Oxgangs Primary School

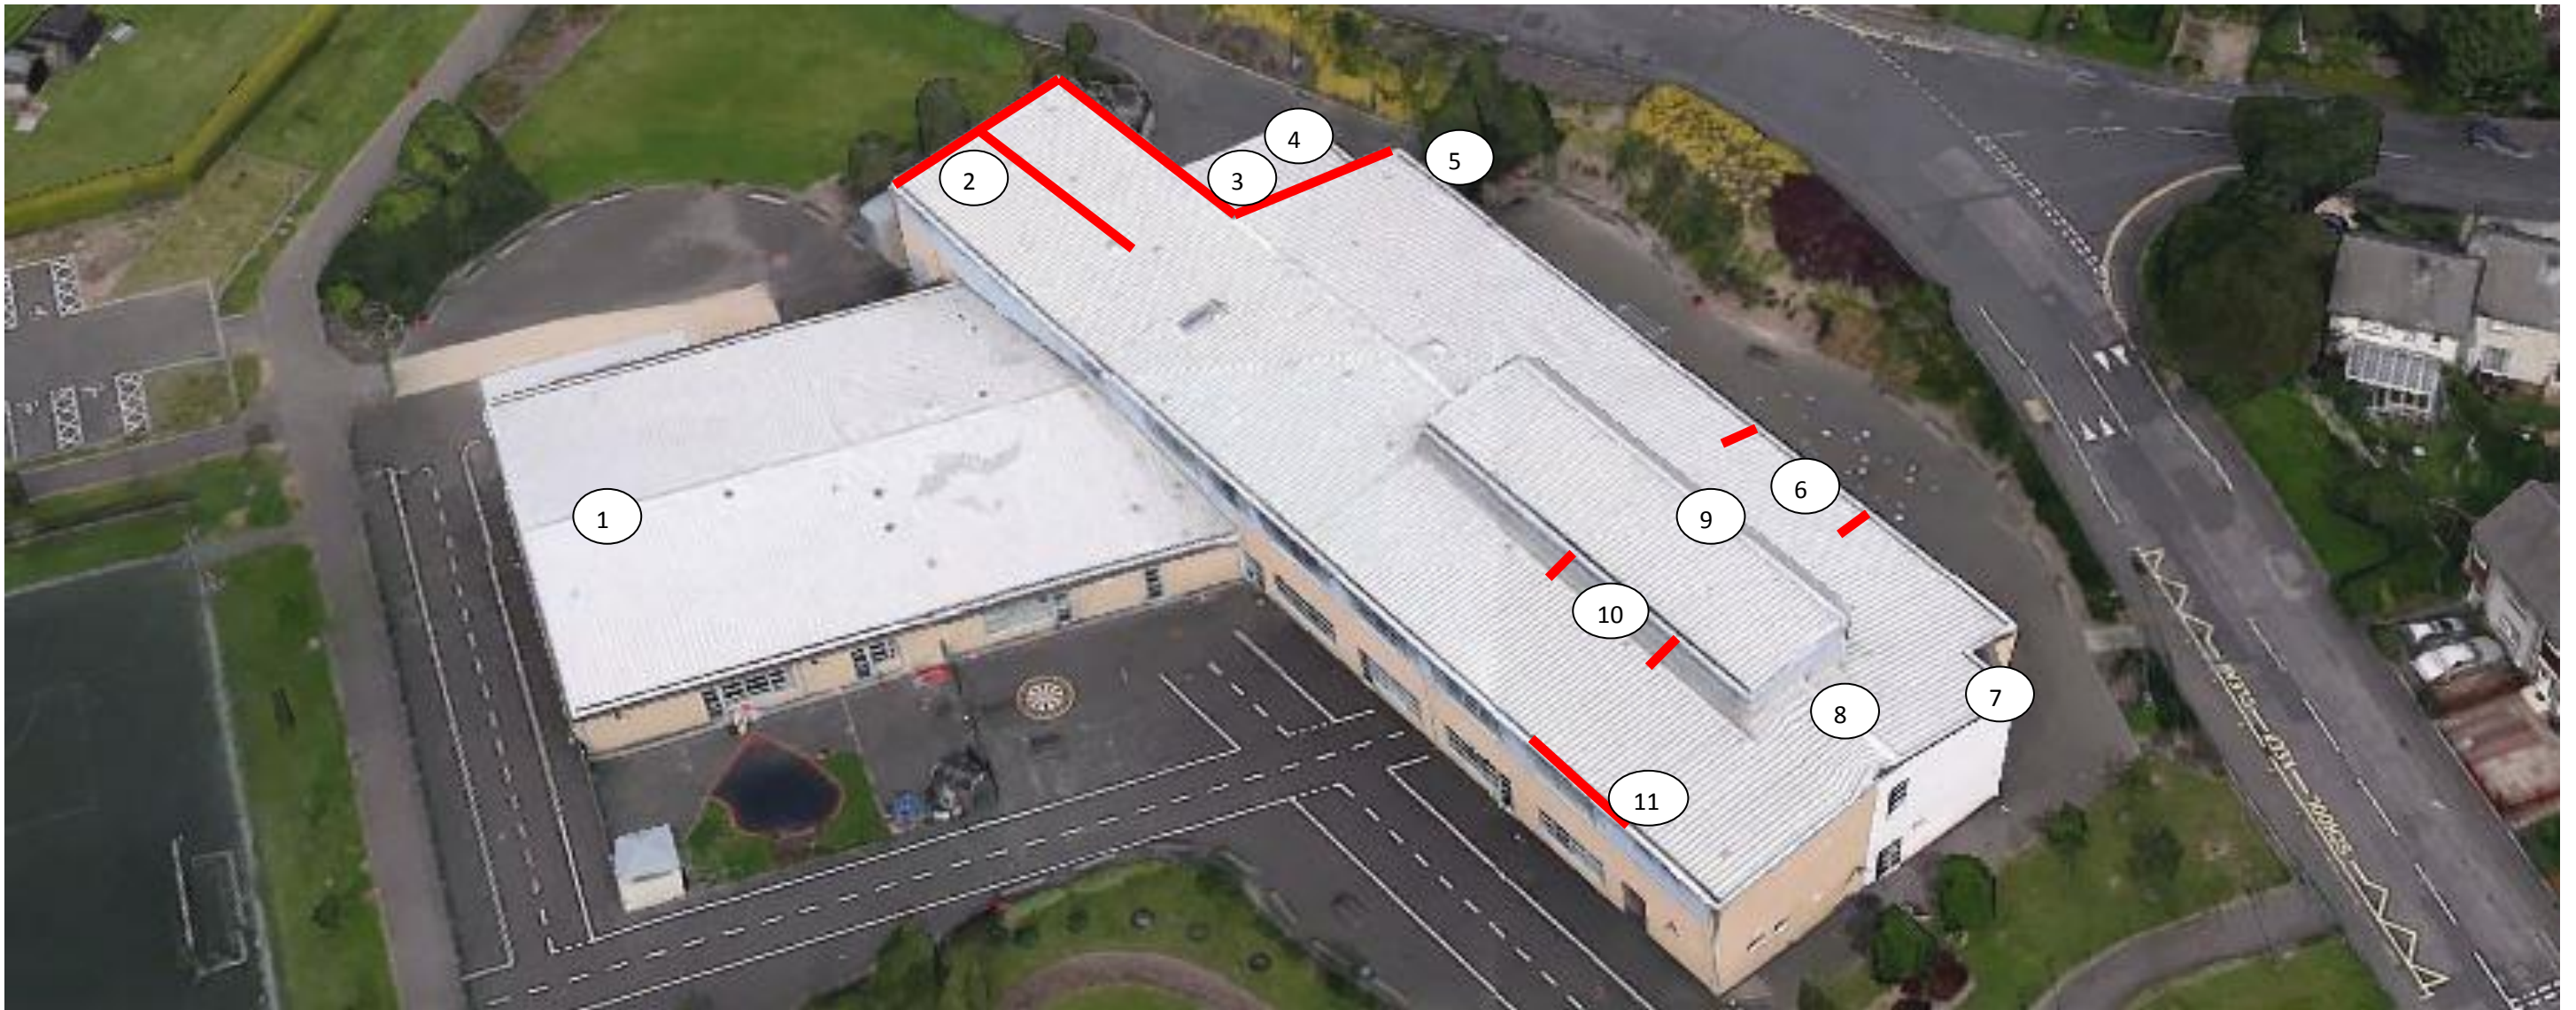
1. Lower roof fixings to be changed to stainless steel.
2. New fixings were installed on Sunday 18th March.
3. Lead needs fixed into the raggle and a new Polysulphide joint.
4. Open areas of cladding, and birds nest present.
5. New sill fixings required.
6. New Tech screws required.
7. New Tech screws were installed on Sunday 18th March.
8. Missing section of cladding.
9. New Tech screws required.
10. New fixings installed on Sunday 18th March; however, mild steel needs to be changed.
11. Open joints require to be sealed.
